ICM D Customer Care Information from Dec. 6st, 2000 – limited distribution to the affected countries -

Subject: faulty capacitors on Gigaset 3010 ratio

Example of date code
M = 2000 9 = Sept.

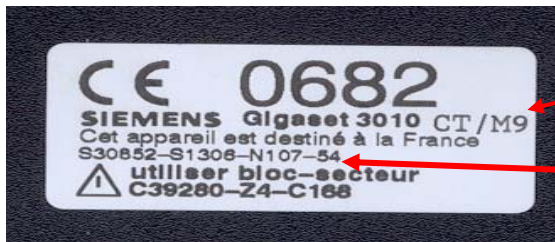
Gigaset 3010 ratio base station (state > 50 (figure after the last dash in the part-no.))

State > 50 (here 54) indicates
that this is a ratio version

See **excel table** attached to this document for the affected countries and amounts. These countries are the main focus. There can be also other countries affected. The date code of the affected devices is within M8 (August) to MN (November).

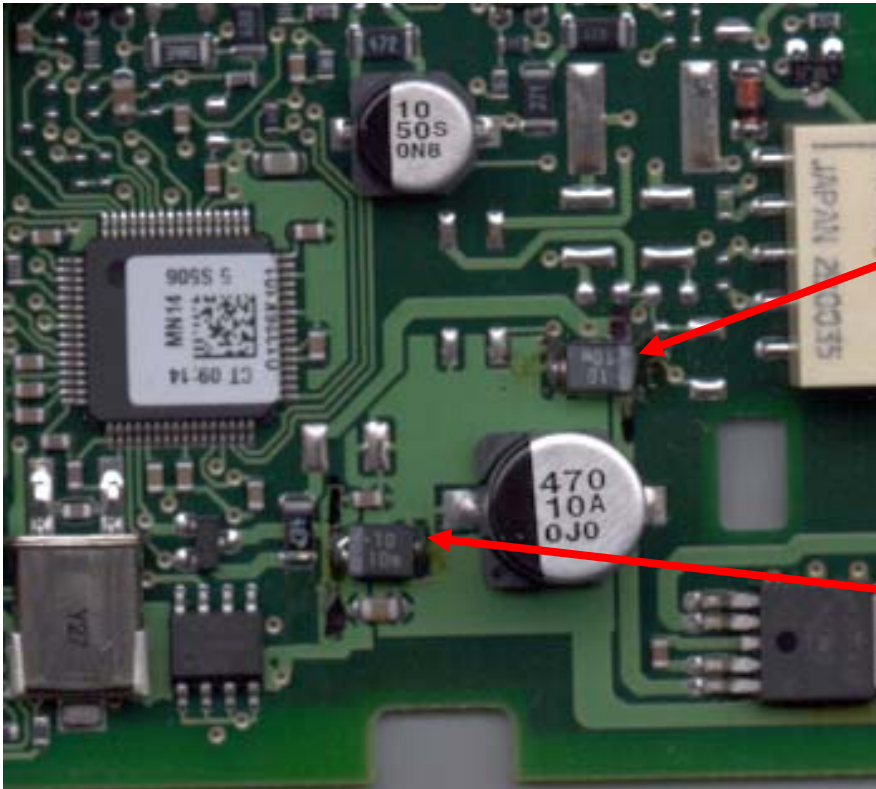
The boards of the affected base stations have been equipped with Tantal capacitors with wrong polarity (C511, C654). After a short time of usage the capacitors short-circuit and cause a breakdown in the voltage.

Every affected new base station (from the sales stock) has to be repaired by desoldering the capacitors turning them for 180° and resoldering them. If the base station has been manufactured with **ceramic capacitors 2**. (Photo below) there is **no need of replacement**.

Regarding devices that have been returned from the customer the capacitors must be replaced by new ones (see right polarity on the photos below).

The plus pole of the Tantal capacitors is marked with a line.

Note: ESD protection rules and SMT soldering rules have to be followed.

Correct polarity
C654

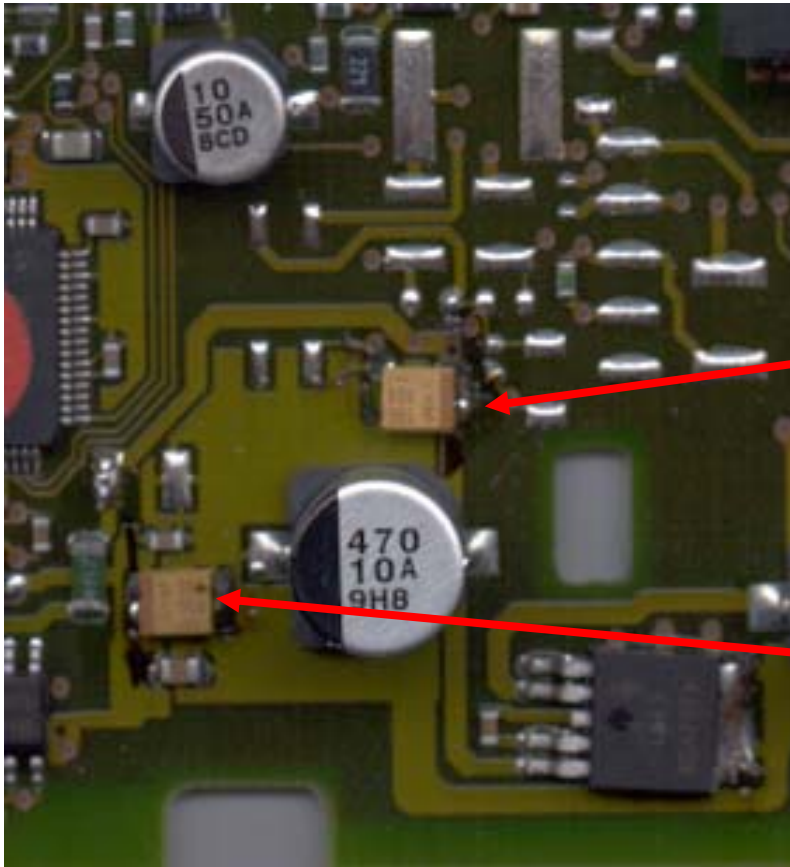
See pictures below for correct soldered Tantal capacitors and different types of capacitors (yellow (brown line=plus pole) and black (silver line=plus pole)Tantal capacitors)

Correct polarity
C511
